# Access Compliance Report

## Public Rights-of-Way

### (Curb Ramps)

Intersection ID: 47842	Main Street: MANITOBA_LN	Cross Street: CACTUS_VALLEY_RD	Location: SW
ADA ID: 410C0B2F7A36	Ramp Type: Perp	Initial Pass/Fail: Fail	Overall Compliance: No
		Severity Score: 12.5

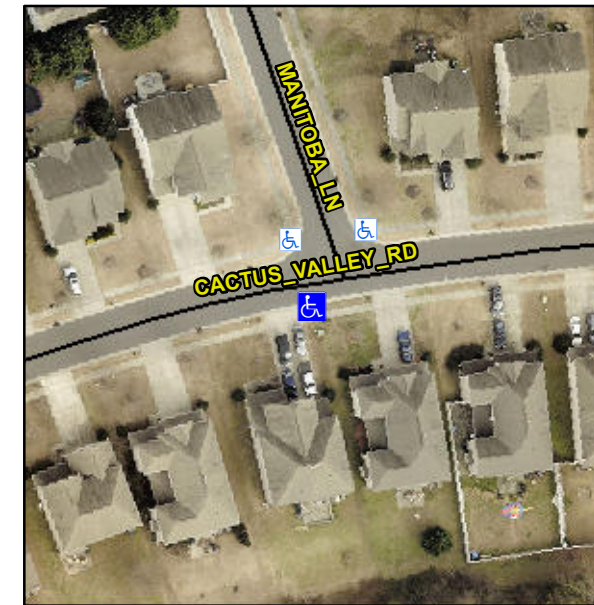
**R304.2.2**

Compliance	Description	Data	Compliance	Description	Data
N/A	Ramp Length (in)	48.0	No	Ramp Slope (%)	10.7
Yes	Ramp Width (in)	48.0	Yes	Ramp XSlope (%)	1.2
N/A	Flare Type LT	N/A	N/A	Flare Type RT	N/A
N/A	Flare Slope LT (%)	N/A	N/A	Flare Slope RT (%)	N/A
N/A	Flare Traversable LT?	N/A	N/A	Flare Traversable RT?	N/A
N/A	Landing Length (in)	N/A	N/A	DWS Provided?	N/A
N/A	Landing Width (in)	N/A	N/A	DWS Contrast?	N/A
N/A	Landing Slope (%)	N/A	N/A	DWS Length (in)	N/A
N/A	Landing X Slope (%)	N/A	N/A	DWS Full Width?	N/A
N/A	Landing Curb? (Y/N)	N/A	N/A	DWS Offset (in)	N/A
N/A	Shared Landing?	N/A			
N/A	Gutter Ponding?	N/A	N/A	Gutter Slope (%)	N/A
N/A	Gutter Lip Ht (in)	N/A	N/A	Gutter X Slope (%)	N/A
N/A	Painted X Walk1?	No	N/A	Painted X Walk2?	N/A
	X Walk 1 Direction	To NW		X Walk 2 Direction	N/A
N/A	X Walk 1 Width (in)	N/A	N/A	X Walk 2 Width (in)	N/A
	X Walk 1 Slope (%)	1.6		X Walk 2 Slope (%)	N/A
	X Walk 1 X Slope (%)	1.7		X Walk 2 X Slope (%)	N/A

**Remove & Replace Entire Ramp.**
